| TO: Mercedes-Benz Dealer Principals, General Managers, Sales | FROM: Gregory Gunther, Department Manager, Vehicle |
|--|--|
| RE: Emission Modification Notification – [[2020050022]] | |
| MY 10-12 GL350 BlueTec 4MATIC Update – Emission | DATE: May 25, 2022 |

SUBJECT:Model GL-Class diesel vehicles (X164 platform)Model Year 2010-2012Modification to the emission control system

Emission Campaign Bulletin

1.4 Pre-Inspection Overview (Figure 1)

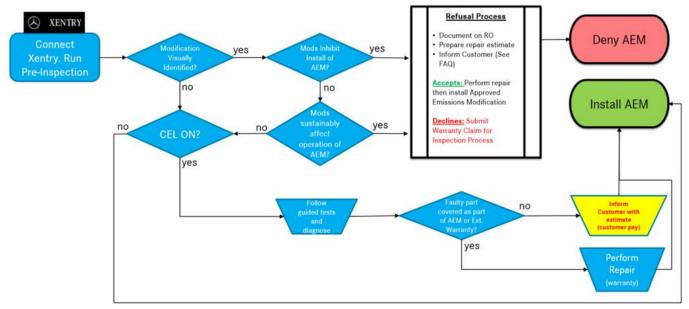
I Note: goal of the pre-inspection process is to perform an inspection of the emission system and ensure all components are present and functioning correctly (Check engine light "CEL" ON/OFF). The pre-inspection consists of the following procedures as displayed in the below flowchart:

- 1. Visual inspection of the emissions system to check for non-compliant alterations to the emission system that impedes the installation of the AEM or substantially effects the operation of the AEM after installation. This consists of a brief visual inspection and does not require a technician to confirm if components are operating correctly. (Example: missing emission system components not replaced as part of the AEM)
 - a. If an alteration has been found during the visual inspection that meet the criteria mentioned in point 1, please advise the customer these alterations must be reversed at their expense before to proceed with the AEM. Please follow the below process to submit a warranty claim for the time associated to diagnosis and provide an estimate to the customer.

- 2. Initial Short Test to check for CEL ON/OFF: Pre-existing issues (CEL ON) may be addressed at the time of AEM install if the components diagnosed are part of the AEM or extended warranty. For all other components, please provide a customer a repair estimate and document if the customer approves/declines the additional repair(s). It is essential the AEM is installed regardless if the customer approved/declines additional repairs to address a pre-existing issue. A list of applicable extended warranty parts is available in Xentry for the technician to refer to.

Figure 5

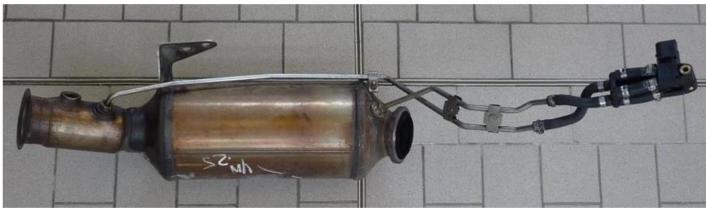
4. Replace components of the exhaust system DPF/DOC A 164 490 17 00 80 and SCR catalyst A 164 490 09 00 80.
i For basic data see AR49.10-P-7100GZB, AR49.10-P-5501GZB, AR49.10-P-7000GZB,

Li Catalytic converter diesel particulate filter unit with connected differential pressure lines **(Figure 5)**. Rebuild the differential pressure lines only in the removed state.

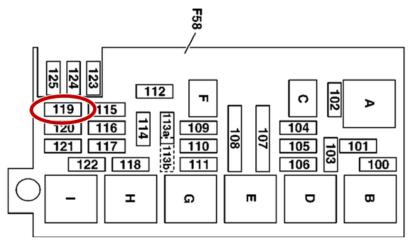
6. <u>Replace the DEF injection nozzle (A 164 490 26 00 80).</u>
